ADDENDUM #9

RE: Addendum #9
Electronic Access & Video Surveillance
Tyler Junior College
RFP #24-07

Wesley House First Floor

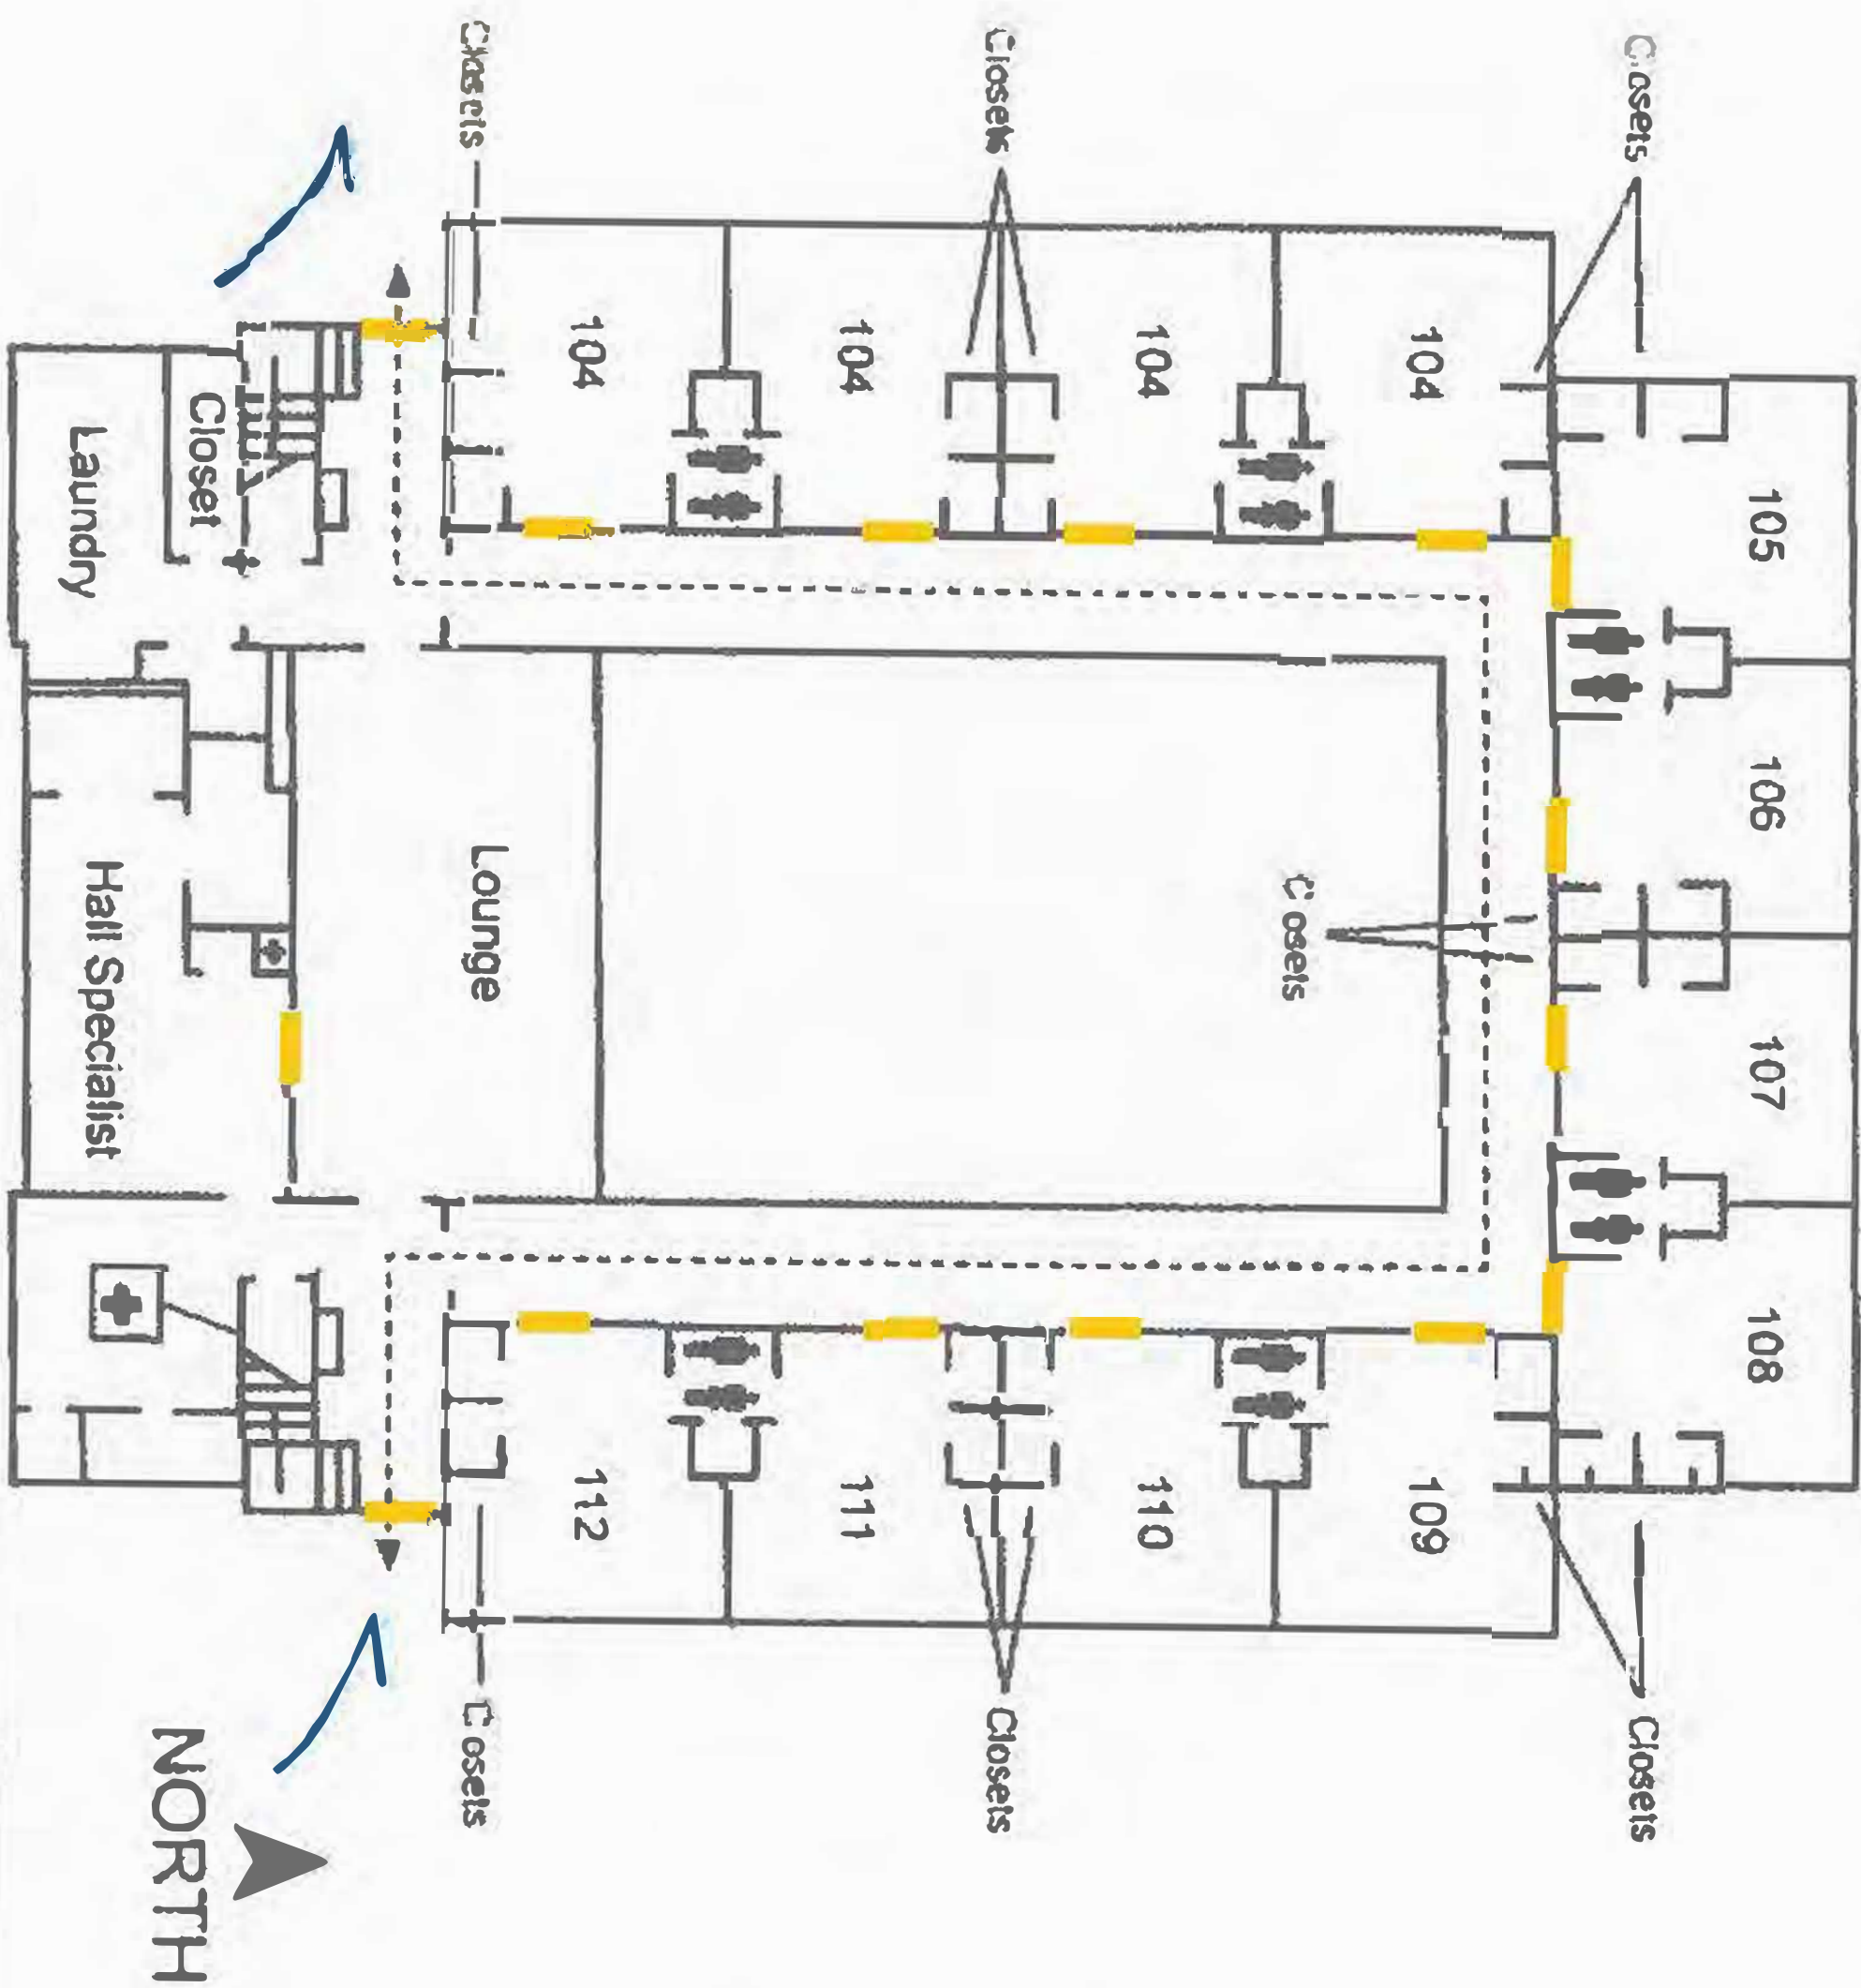
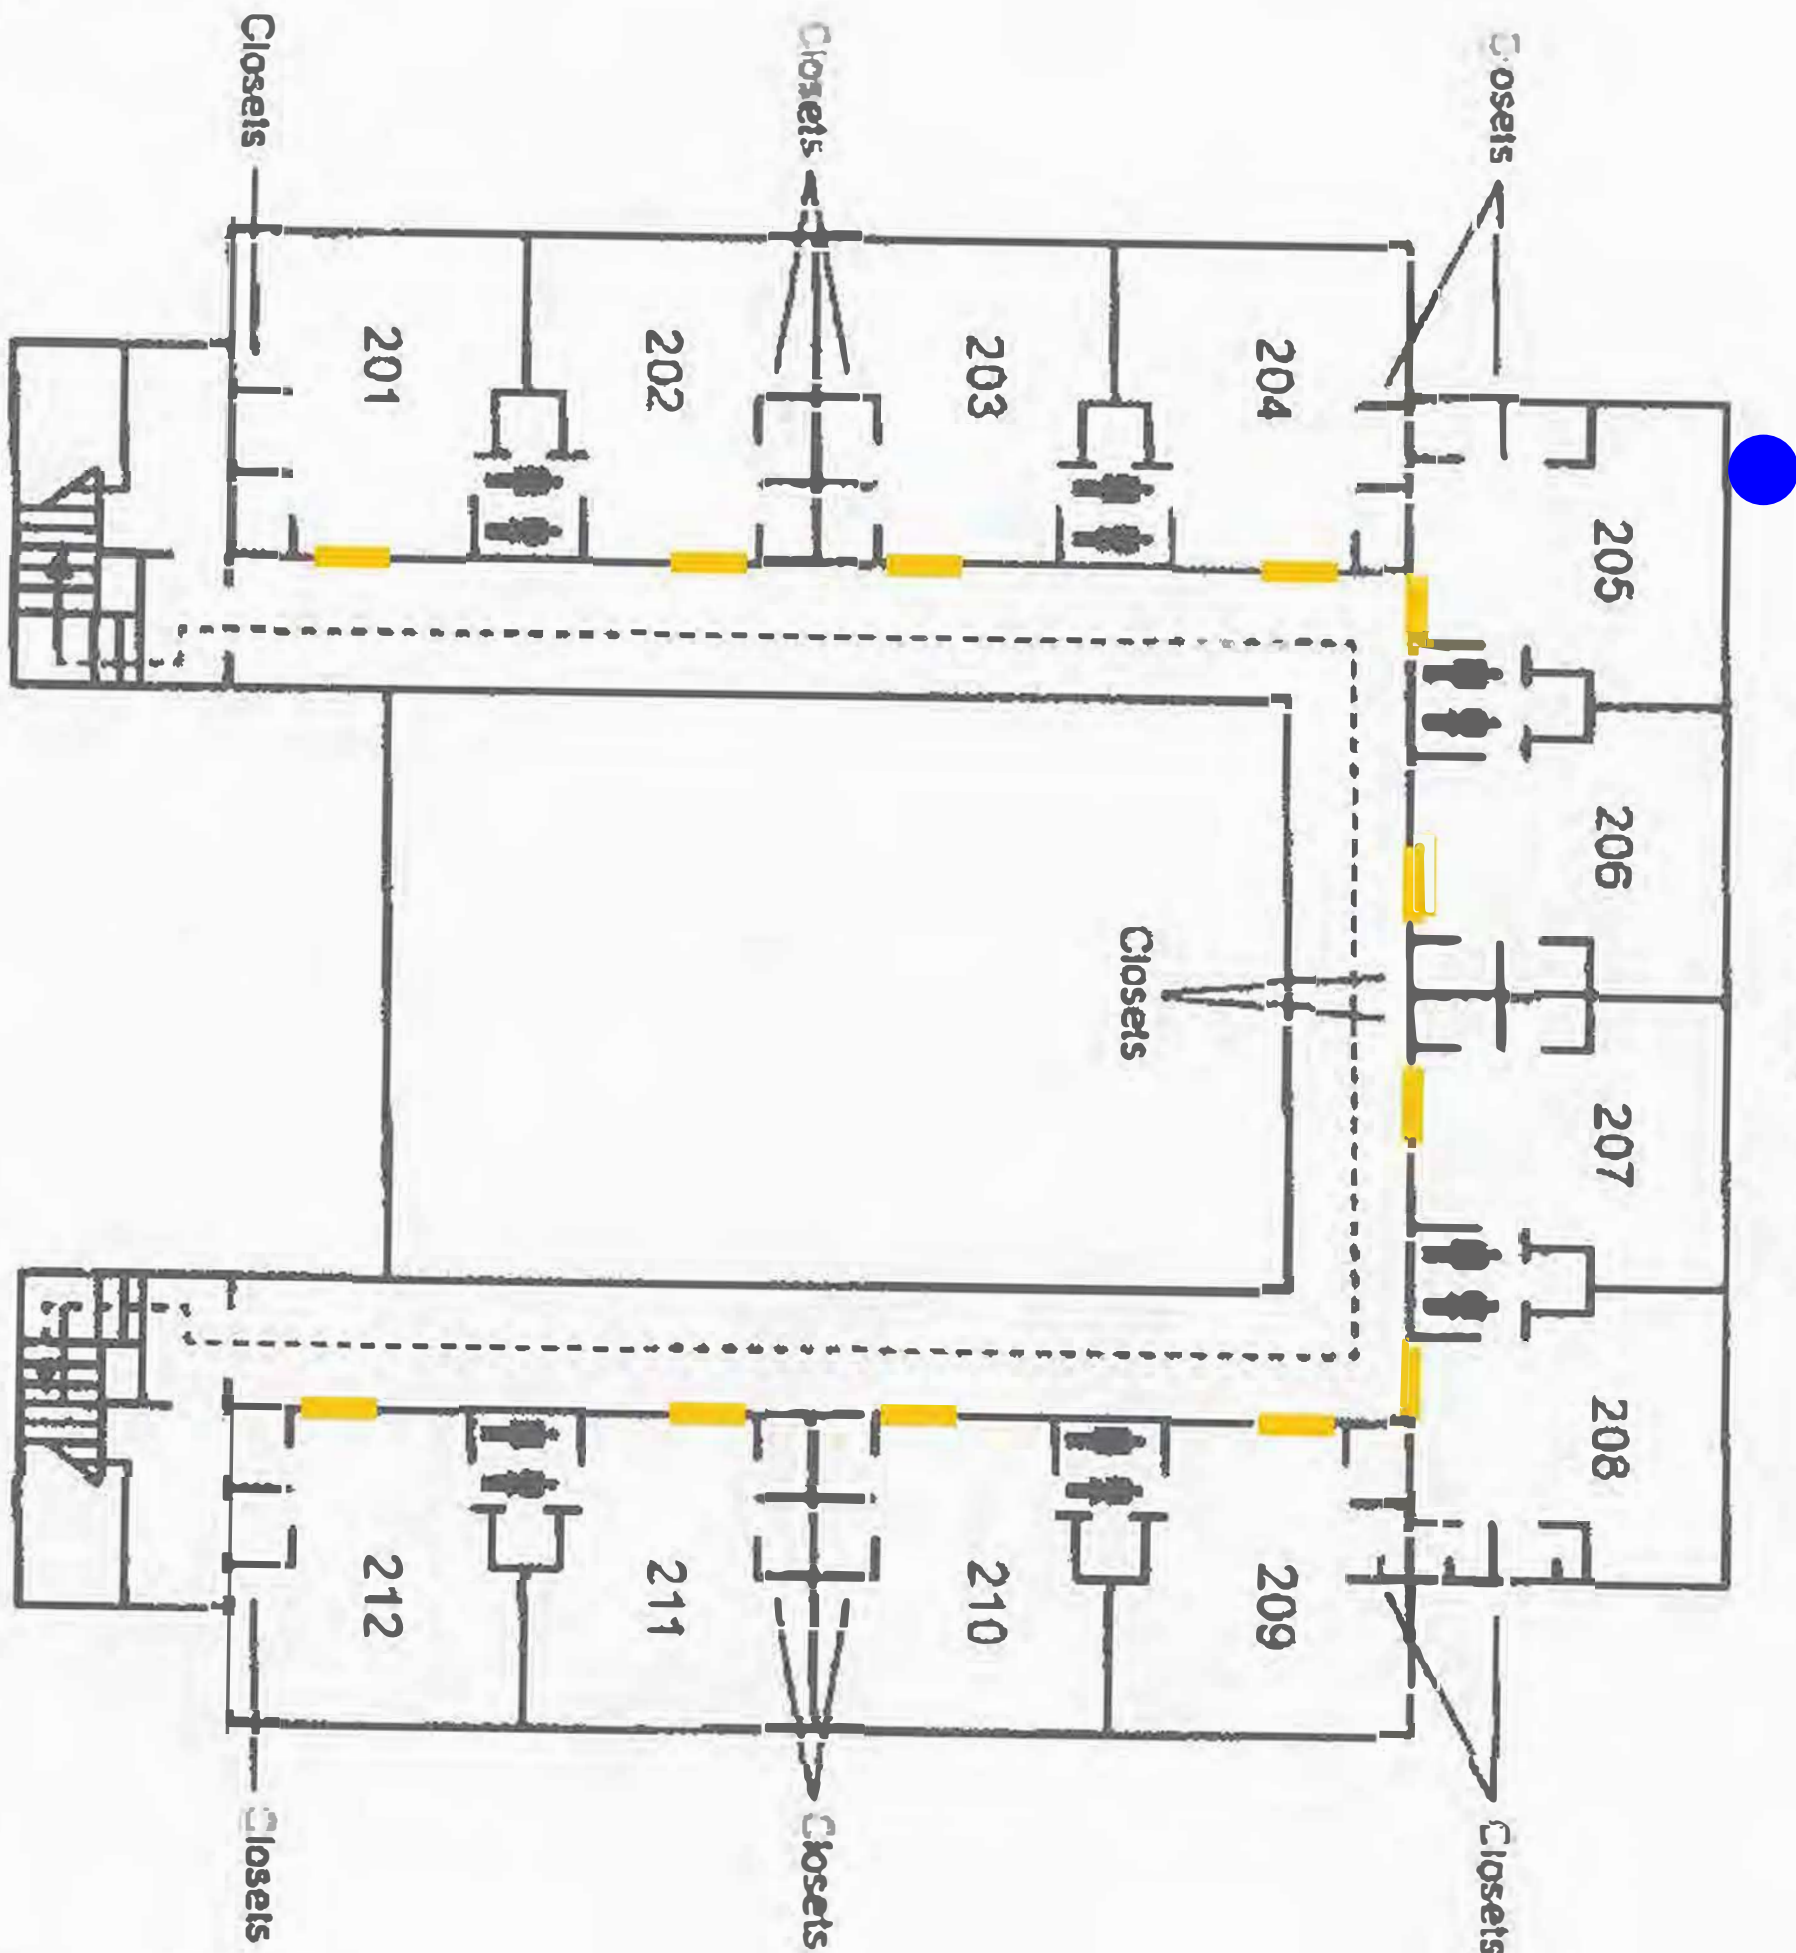
QUESTION #24: Noted that counts for Wesley House (Lewis and West) reflect the following:

1. Wesley House Lewis – drawing shows mark-up for 27 Onity locks, but addendum says 36.
2. Wesley House West – no mark-up on drawing to perform counts, but addendum says 27.
3. Are these numbers possibly flipped?
4. Will there be a marked-up Wesley Hall West drawing?

ANSWER: There are 27 locks in Lewis and West. An updated map has been attached.
